Final Master Environmental Impact Report

City of Morgan Hill Downtown Specific Plan

CITY OF MORGAN HILL

October 2009

FIGURE 22 (REVISED)

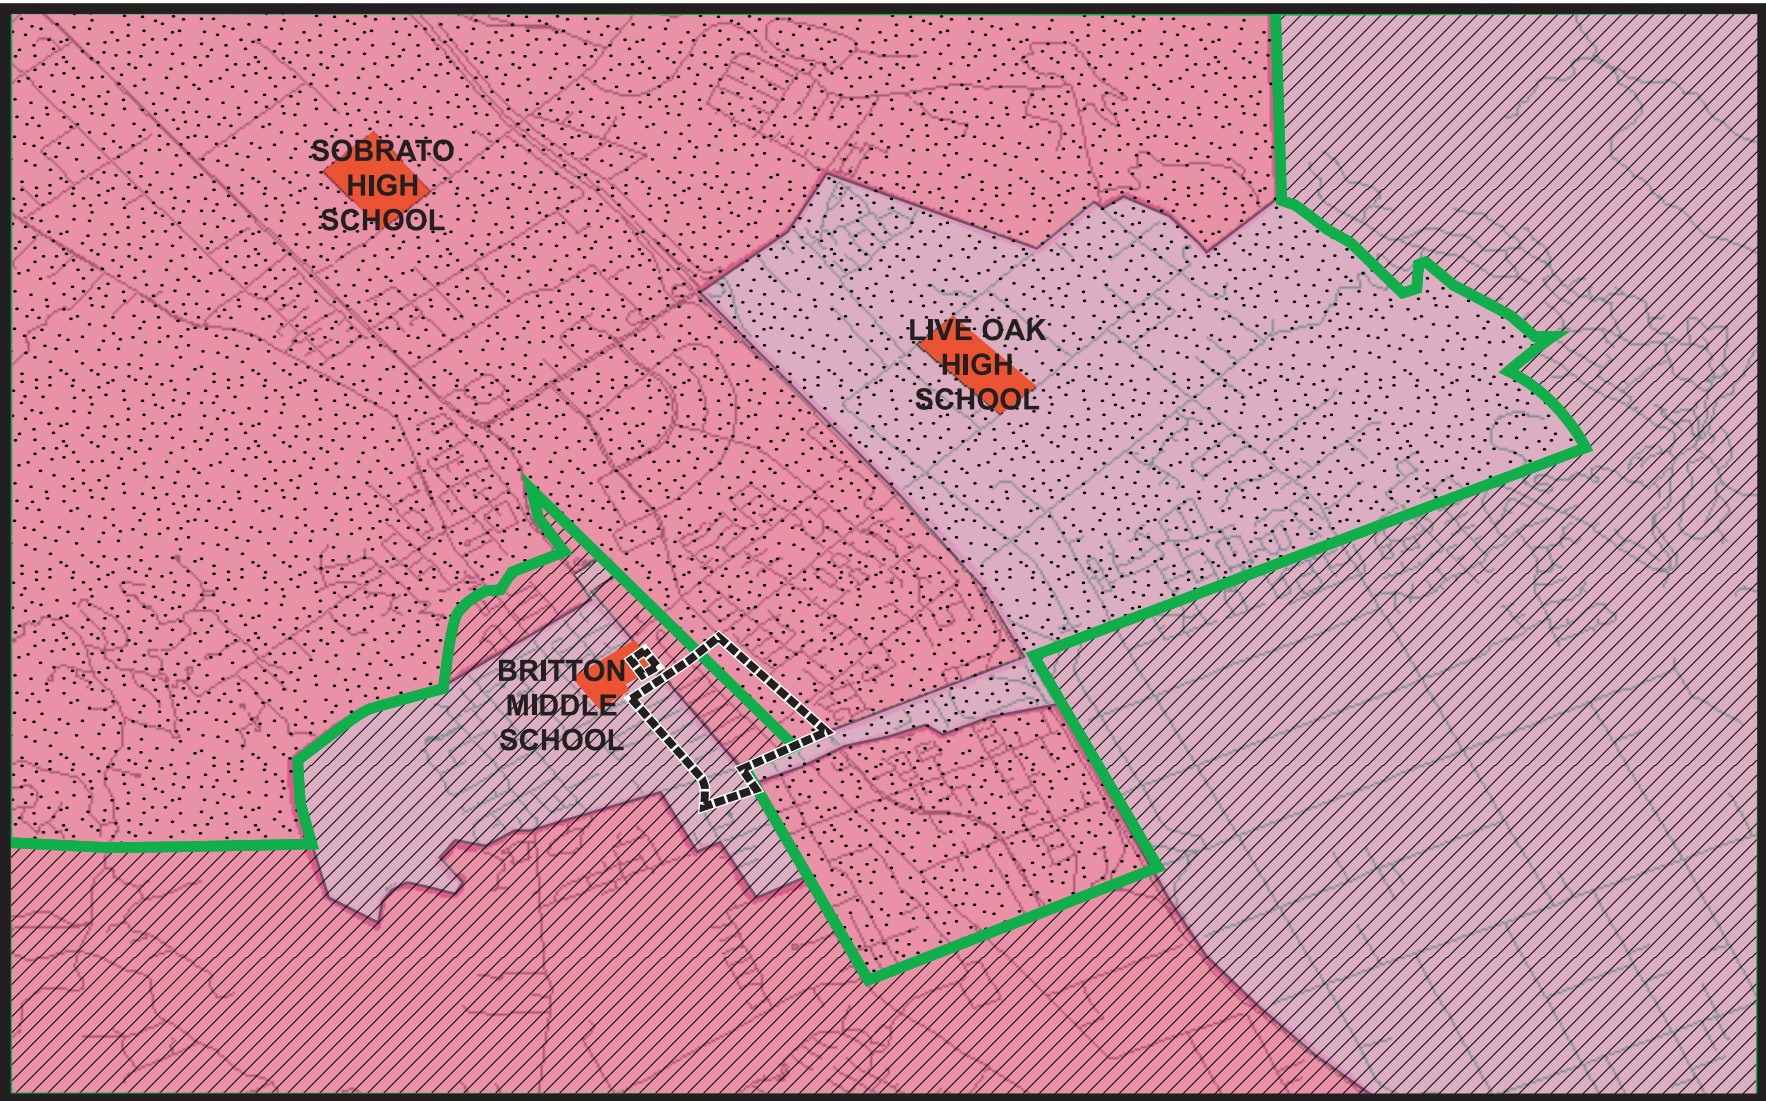
Page 208 Section 3.13.2.3 Schools; **Revise** the School Attendance Boundaries Figure 22 as shown on the following page.
